WINSTON SQUARE SUBDIVISION

The purpose of this application is to subdivide multiple metes and bounds parcels into 11 lots.

DETAIL SITE PLAN

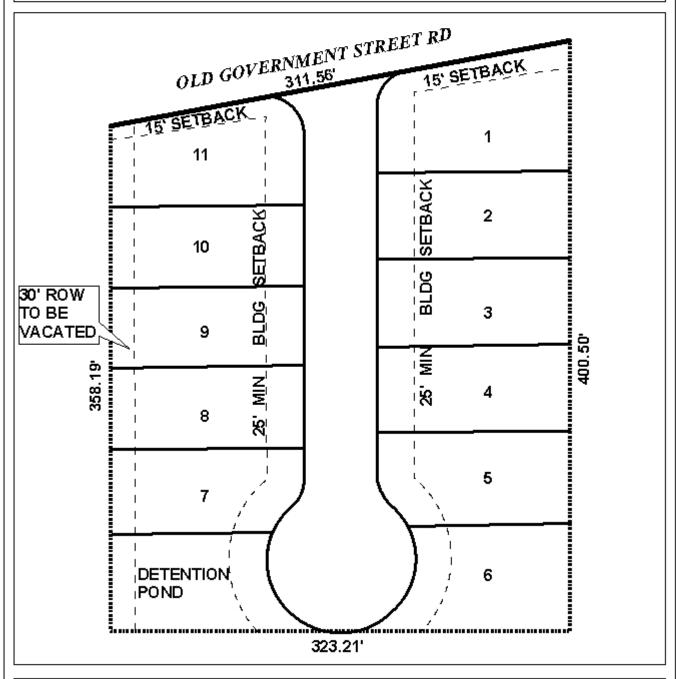
As proposed, Lots 1 and 11 would have frontage along Old Government Street Road and the new street; therefore, the placement of a note on the final plat stating the Lots 1 and 11 are denied direct access to Old Government Street Road, should be required.

As illustrated on the plat, the applicant is proposing to vacate 30' of unopened right-of-way along the western boundary. As this "strip" of land is essential to subdivision approval, the vacation process should be completed prior to the recording of the final plat.

The applicant is proposing a 15' side yard setback along Old Government Street Road. The Planning Commission typically does not allow a reduced setback unless the subdivision is part of a Planned Unit Development or because of a physiographic problem. The applicant has not stated why a 15' setback is requested. The Subdivision Regulations require a 25' front yard setback from the property line; however, the Planning Commission typically refers to the Zoning Ordinance when an applicant requests a reduced setback on a corner lot. The Zoning Ordinance allows a 20' minimum setback for corner lots to allow for increased visibility at intersections. It should be noted that Lots 1 and 11 are the two largest lots of the proposed subdivision and a 20' side yard setback would be more appropriate and is typical of the Planning Commission approvals for corner lots.

There is an area labeled for detention but not labeled as a common area; therefore, a note identifying this area as detention, as well as a note stating that the maintenance of the common area is the responsibility of the property owners should be required on the final plat.

The plat meets the minimum requirements of the Subdivision Regulations and is recommended for Tentative Approval subject to the following conditions: 1) the placement of a note on the final plat stating the Lots 1 and 11 are denied direct access to Old Government Street Road; 2) the vacation process be completed prior to the recording of the final plat; 3) the provision of a 20' side yard setback along Old Government Street Road; 4) the detention pond be labeled as common area and a note placed on the final plat stating that the maintenance thereof is the responsibility of the property owners; and 5) the placement of a note on the final plat stating any lots which are developed commercially, and adjoin residentially developed property, must provide a buffer, in compliance with Section V.A.7. of the Subdivision Regulations.
